Project	IEEE 802.16 Broadband Wireless Access Working Group < http://ieee802.org/16 >	
Title	Corrections for the MS's Authorization Flow	
Data Submitted	2005-04-27	
Source(s)	Seokheon Cho Sungcheol Chang Chulsik Yoon, ETRI 161, Gajeong-dong, Yuseong-Gu, Daejeon, 305-350, Korea	Voice: +82-42-860-5524 Fax: +82-42-861-1966 chosh@etri.re.kr
Re:	IEEE P802.16e/D7	
Abstract	The existing PKMv2 is somewhat unorganized and insecure security framework. This contribution provides a resolution for unorganized and insecure MS's authorization flow in the PKMv2.	
Purpose	Adoption of proposed changes into P802.16e/D7	
Notice	This document has been prepared to assist IEEE 802.16. It is offered as a basis for discussion and is not binding on the contributing individual(s) or organization(s). The material in this document is subject to change in form and content after further study. The contributor(s) reserve(s) the right to add, amend or withdraw material contained herein.

Corrections for the MS's Authorization Flow

0.1 IEEE P802.16e/D7 Status

Proposed Changes into IEEE P802.16e/D7

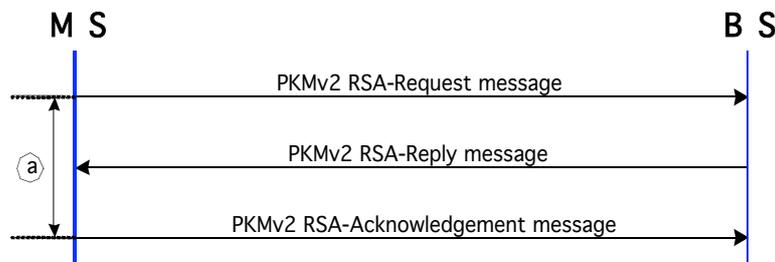
- _ For the RSA-based Authorization procedure:
 - The Authorization Request message and the Authorization Reply message in the RSA-based Authorization procedure are in the same rank as the EAP Transfer message in the EAP-based Authorization procedure. The Authorization Request/Reply messages contains Security-Capabilities, SAID, and SA-Descriptors, but the EAP Transfer message doesn't contain those parameters.

- The sequence number and lifetime included in the RSA-based Authorization procedure are not an AK sequence number and AK lifetime.
 - When the RSA-based Authorization procedure is selected, there is no message for informing the MS's authentication failure from BS to MS and the BS's authentication result (such as success or reject) from MS.

- _ For the EAP-based Authorization procedure:
 - The Key Sequence Number used in the Authenticated EAP-Transfer message is not an AK Sequence Number.
 - The BS doesn't know the completion time of the EAP-based Authorization procedure in case that EAP protocol doesn't yield AAA-key and whether an MS receives the last EAP Transfer message (such as "EAP Success" used in EAP-TLS) or not. Both the BS and the MS cannot simultaneously share the AK derived from PMK, when an MS doesn't receive the last EAP Transfer message.

- _ AK generation process needs more secure mechanism.

b) For the EAP-based Authorization procedure:

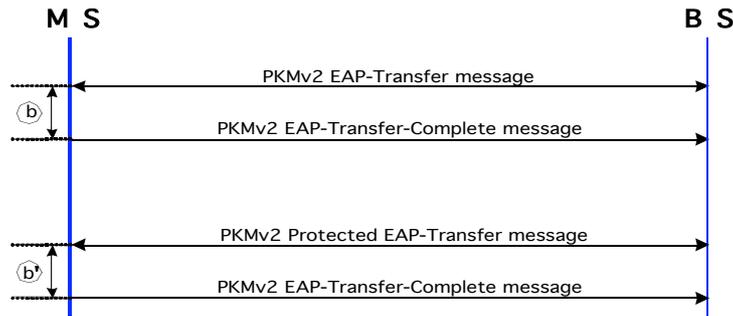
- The messages used in the EAP-based Authorization procedure are as follows
- The Key Sequence Number used in the PKMv2 Authenticated EAP-Transfer message is not an AK sequence number but PAK sequence number.
- In order that BS knows the completeness time of EAP-based Authorization procedure in case that EAP protocol doesn't yield AAA-key and whether a MS receives the last EAP Transfer message (such as "EAP Success" used in EAP-TLS) or not, an MS shall send the PKMv2 EAP-Transfer-Complete message to report EAP-based Authorization completeness. Therefore, both MS and BS can synchronize the AK.

- i. PKMv2 EAP-Transfer message: EAP Payload
- ii. PKMv2 Authenticated EAP-Transfer message: Key Sequence Number (PAK), EAP Payload, OMAC Digest (from EIK)
- iii. PKMv2 EAP-Transfer-Complete message:

c) For MS's Authorization Key Generation procedure:

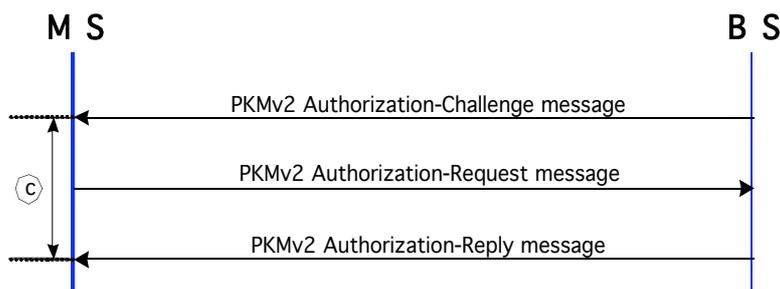
- To assure more secure AK, seeds (such as MS_Nonce and BS_Nonce) should be used to derive AK.
- To protect from replay-attack, the messages needed in MS's AK Generation procedure should contains random number (such as MS_Nonce and BS_Nonce) and message authentication function (such as OMAC Digest).
- The messages with important parameters, e.g. Security-Capabilities, SAID, and SA-Descriptors, should be authenticated.
- This procedure supports secure 3 way handshake.

- i. PKMv2 Authorization-Challenge message: BS_Nonce
- ii. PKMv2 Authorization-Request message: Key Sequence Number (PAK), MS_Nonce, BS_Nonce, Security_Capabilities, SAID, OMAC Digest (from AK)
- iii. PKMv2 Authorization-Reply message: Key Sequence Number (AK), Key Lifetime (AK), BS_Nonce, (one or more) SA-Descriptor(s), OMAC Digest (from AK)
- iv. PKMv2 Authorization-Reject message: Error-Code, Display-String, BS_Nonce, OMAC Digest (from AK)

Figure xxx-MS Authorization Procedure in PKMv2

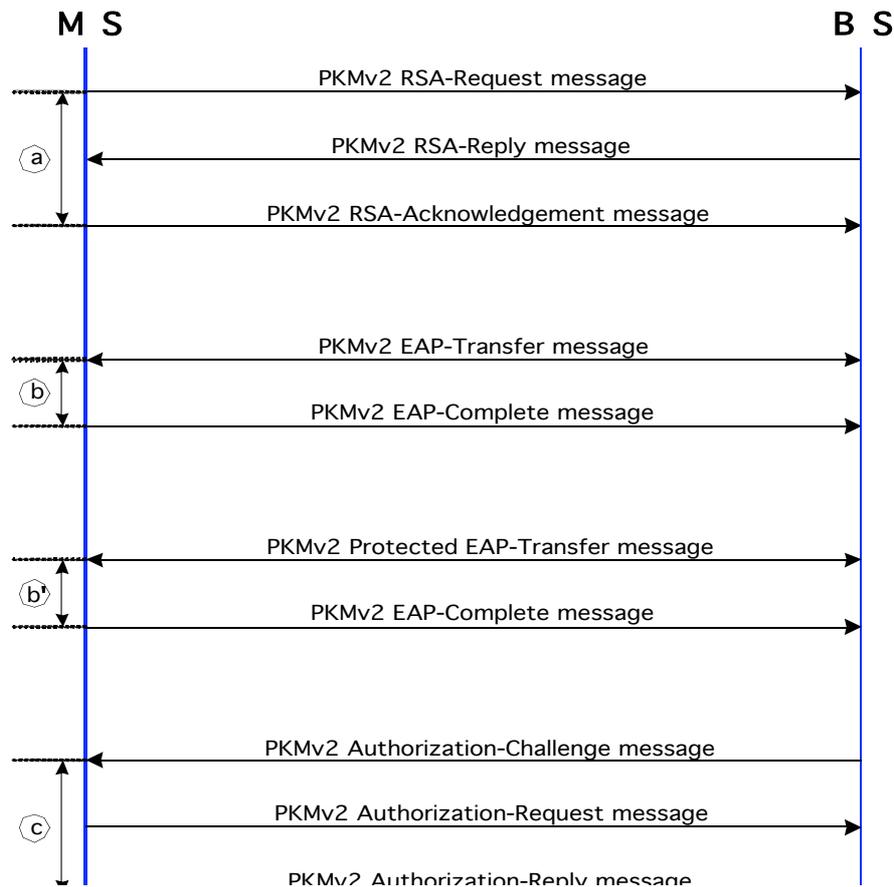
MS authorization procedure in PKMv2 constitutes three authorization exchange ways as shown in Fig xxx. Three authorization exchange ways are the RSA-based authorization process (), the EAP-based authorization process (_ or _ '), and the MS's Authorization Key Generation process (_).

There are PKMv2 RSA-Request, PKMv2 RSA-Reply, PKMv2 RSA-Reject, and PKMv2 RSA-Acknowledgement messages needed in the RSA-based authorization process (_). Both MS and BS shall share the same PAK derived from the pre-PAK.

There are two kinds of procedures in the EAP-based authorization process; the EAP Transfer procedure () to transfer only EAP payload and the Authenticated EAP Transfer procedure () to assure secure EAP payload transfer. Both MS and BS can share the same PMK derived from the AAA-key. Depending on the EAP protocol, however, the EAP method used can not yield an AAA-key and both of them shall not share the PMK.

There are PKMv2 Authorization-Challenge, PKMv2 Authorization-Request, and PKMv2 Authorization-Reply, and PKMv2 Authorization-Reject messages needed in the MS's Authorization Key Generation process (). Both MS and BS shall share the same AK derived from the PAK or/and the PMK, obtained in the RSA-based authorization process and the EAP-based authorization process, respectively.

In addition, several combinations of authorization process can be executed to finally obtain the AK in PKMv2 as follows.

- Only RSA-based authorization process () and MS's Authorization Key Generation process ()
- Only EAP-based authorization process (EAP Transfer:) and MS's Authorization Key Generation process ()
- RSA-based authorization process (), EAP-based authorization process (EAP Transfer:), and MS's Authorization Key Generation process ()
- RSA-based authorization process (), EAP-based authorization process (Authenticated EAP Transfer:), and MS's Authorization Key Generation process ()

One of above several authorization processes shall be selected by the Authorization Policy Support field included in the SBC-REQ and SBC-RSP messages.
